**TOWN OF HERNDON, VIRGINIA
HERITAGE PRESERVATION REVIEW BOARD
WORK SESSION AGENDA
APRIL 3, 2019
HERNDON COUNCIL CHAMBERS BUILDING
765 LYNN STREET
7:00 P.M.**

Subject: HPRB #18-31, 610 Spring Street, Addition – Updated Materials

MATTHEWS RESIDENCE ADDITION

1. Concerns about size and massing:

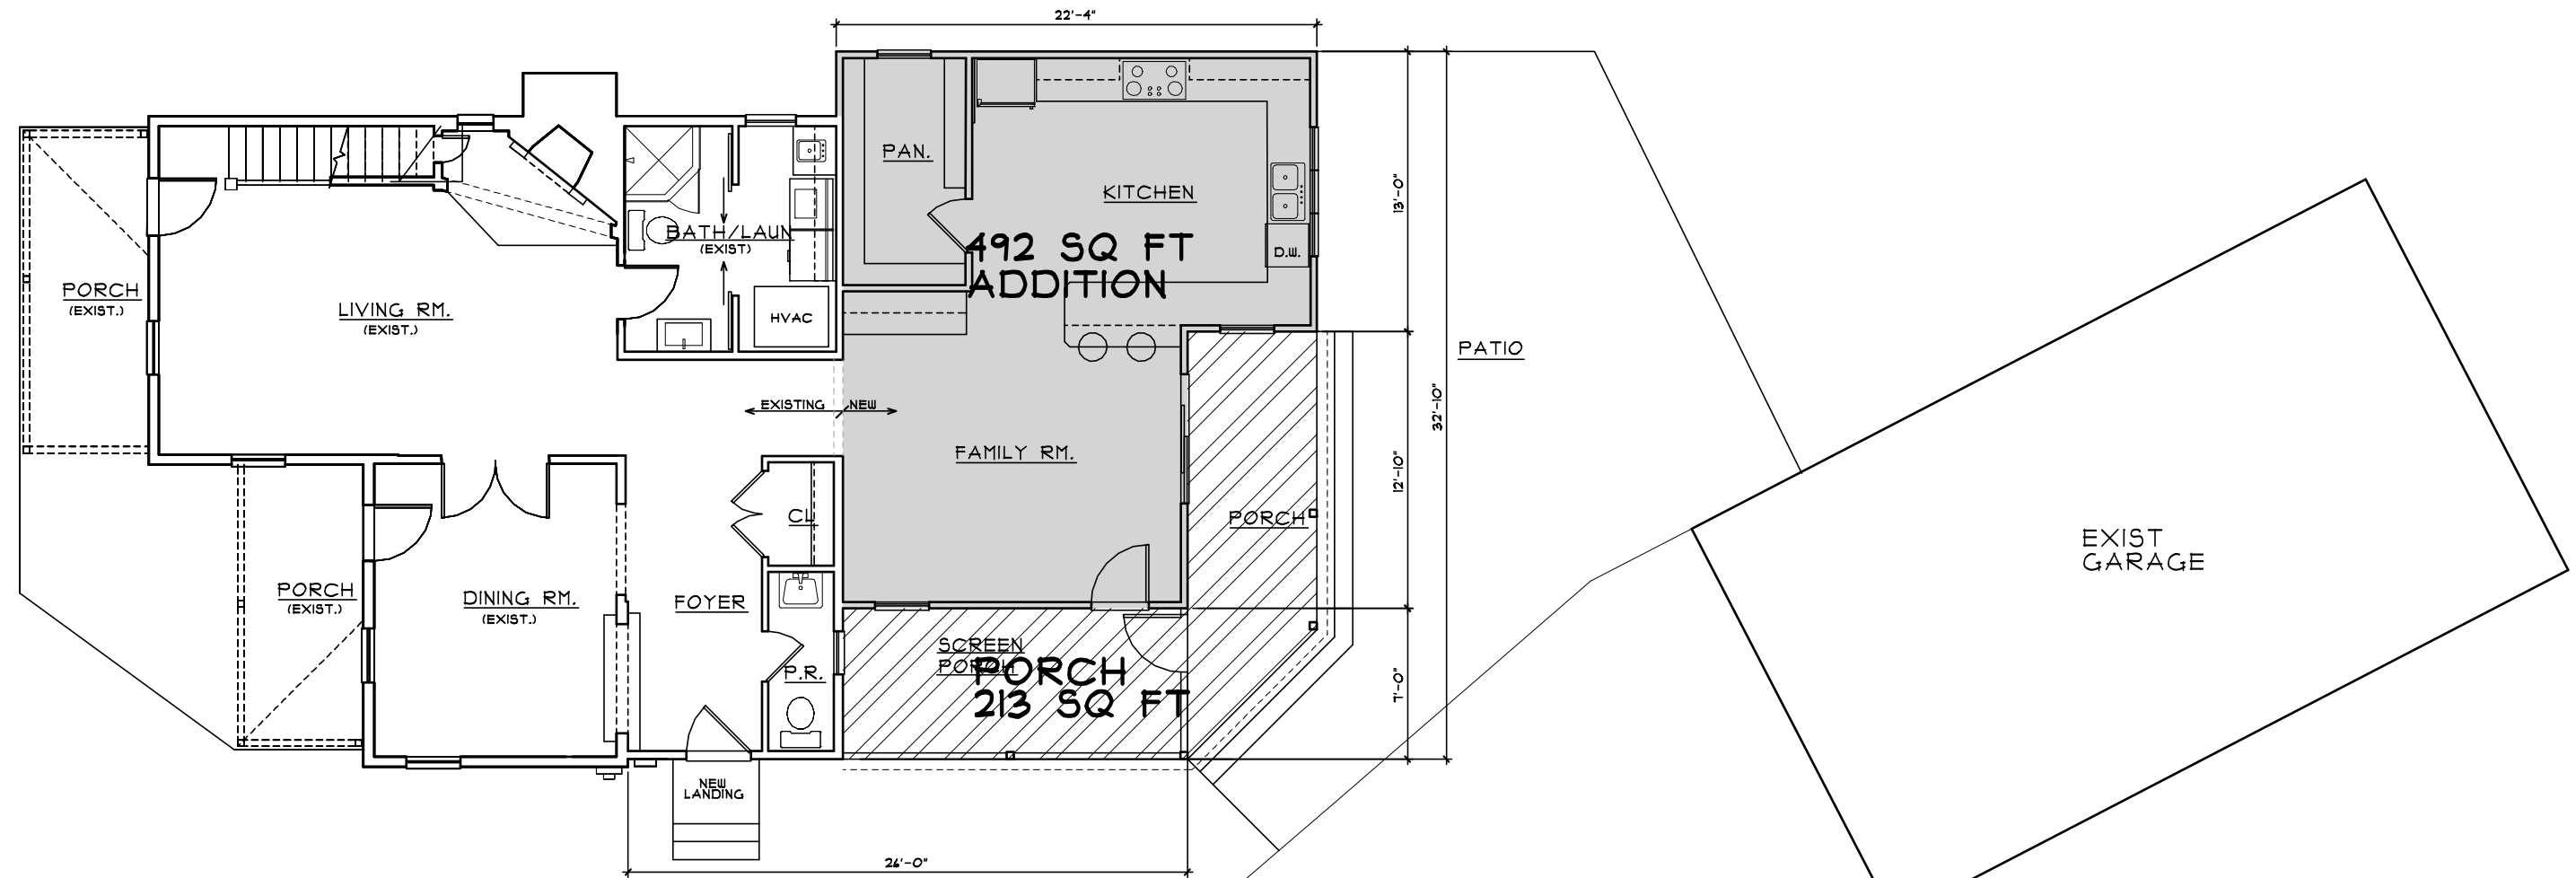
The revisions include several design changes that address the shear mass and scale of the previous design. The size of the second-floor has been reduced, which allowed for a reduction in the size of the gables; on the side elevations to be more in keeping with the size of the existing gables. Also, the roof form on the rear elevation has been broken up into a gable scaled to match the other gables and a hipped roof over the rear porch to reduce the mass and scale of the forms for improved compatibility with the existing house. The side entry porch has been reduced in size by reducing the gable form and no longer extends past the corner of the existing house. Staff believes that the proposed changes are more in keeping with the intent of the Heritage Preservation Handbook Design Guidelines; however, the Board should still focus its discussion and consideration of the appropriateness of the overall size and volume of the addition in contrast to the existing structure.

- Reduced the size of the second floor addition
- Removed the first floor covered entry porch on the right side elevation
- Reduced the size of the cross gable on the second floor of addition. It now matches the width of the south facing gable on front portion of house
- Added trim and the smaller gable to break up the massing on the left side (north) elevation
- Roof over second floor covered porch made into hipped roof to reduce profile and visual impact when viewed from street and backyard

Alterations to the Existing Contributing House

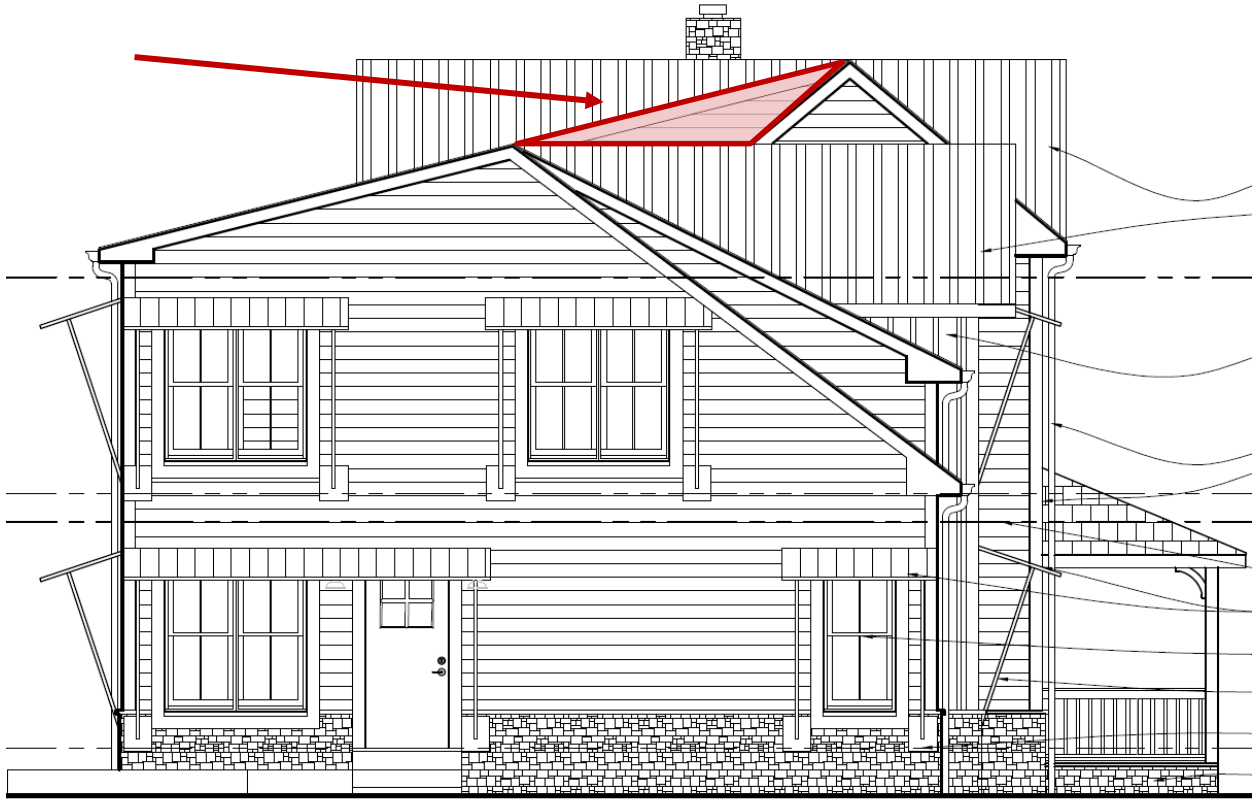
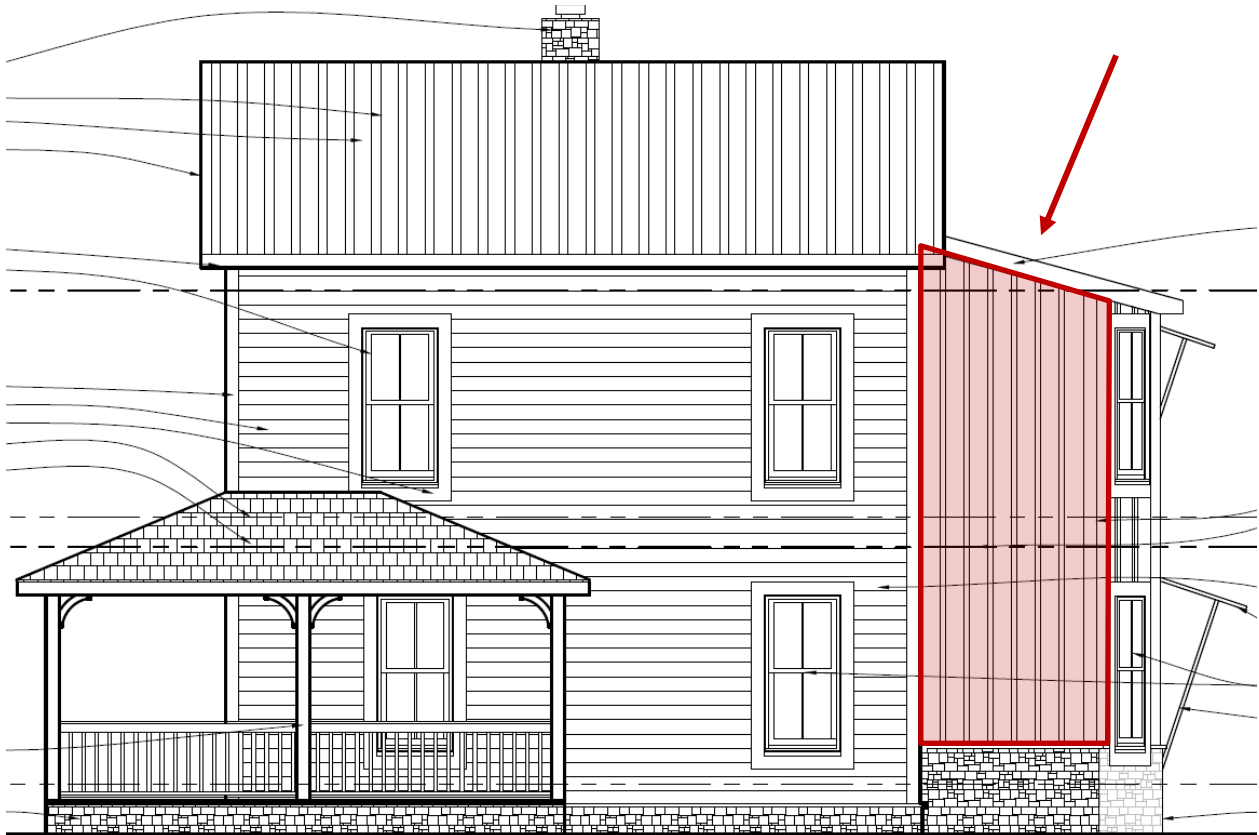
The revisions show several design changes that address the impacts to the historic portions of the house. The two-story bay windows have been removed, the metal awnings have been removed, the porch design has been simplified, the stone veneer has been lowered to the foundation level, and the existing windows locations and sizes have been retained. Combined, these revisions help to preserve the historic appearance of the house however, staff continues to have concerns regarding the primary gable or roof form and the removal of the existing brick chimneys. The primary side gable roof of the house would be rebuilt with a significantly different slope and size (See graphic below).

The change changes a historic roof line, and altered the mass and design of an important historic portion of the house. The existing two-story addition was able to retain the original roof slope/design by using a low-pitched roof. Staff suggests a similar solution to the new addition. Changing the roof slope/design as proposed also confuses any distinction between the historic portions of the house and the addition as viewed from the rear elevation which faces a public right-of-way and creates a single large roof mass (See graphic below).

The existing brick chimneys are both an important architectural and historic element. They are comprised of original material, present a historic design, and are indicators of an historic layout and historic heating source. They should be repaired and retained at their existing locations and with their existing design and material. Photos of chimneys from Nash Street and Spring Street are below.

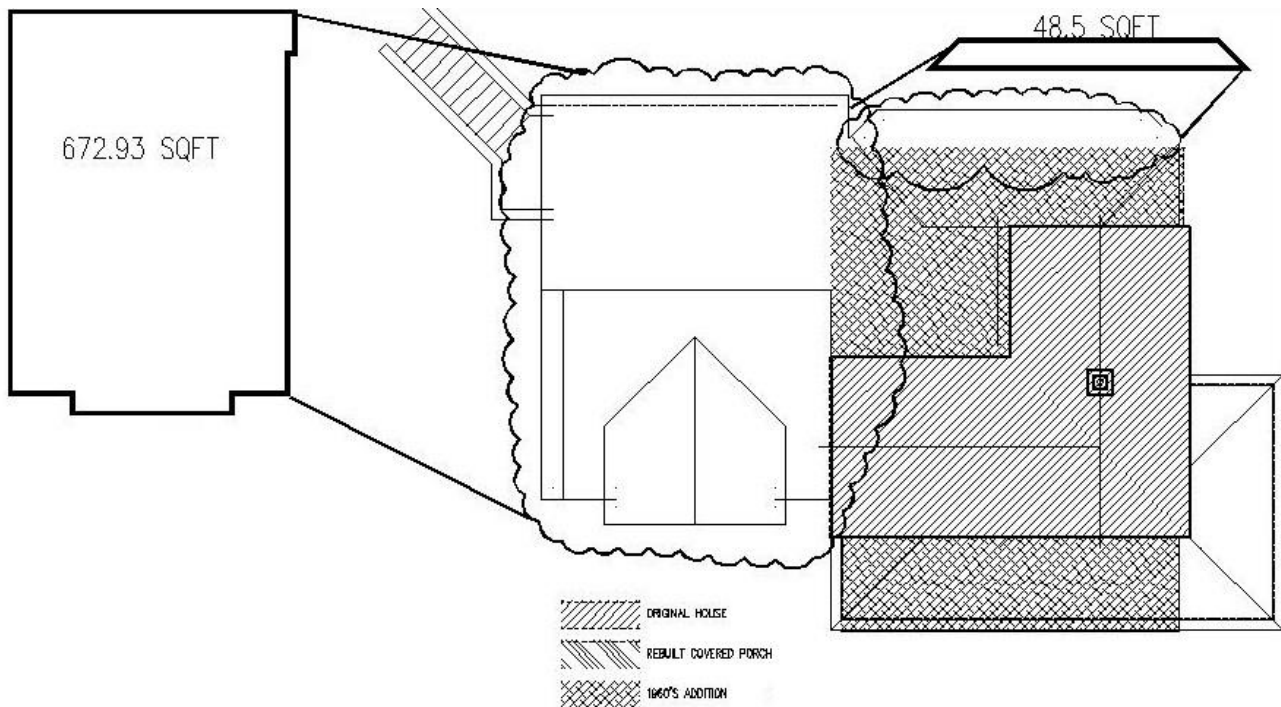
Thank you for the opportunity to present our project to the HPRB. This letter is response the HPRB staff comments dated 6 March 2019 on application HPRB #19-08 for Mr. Francis Kenney Jr at 641 Nash St.. Following the meeting, my client and I meet with the Town Planner Mr. Garcia to discuss the comments from the board and from the staff comments. Based of the board comments and the staff comments, modifications were made to the proposed project to focuses on the Preservation / Rehabilitation of the original structure at 641 Nash St. to the greatest aspect possible.

Based on the members comments, we made the following adjustments:

1. Removed the (2) multistory bump outs on the North western corned of the house.
2. Removed the additional window on the first elevation
3. Revised the existing front elevation proposal to proposal to replace the existing windows with new window that match the exist window size and mullions layout.
4. Revised front porch replacement to a simpler form.
5. Removed the modern sun shading devices that were previously proposed.
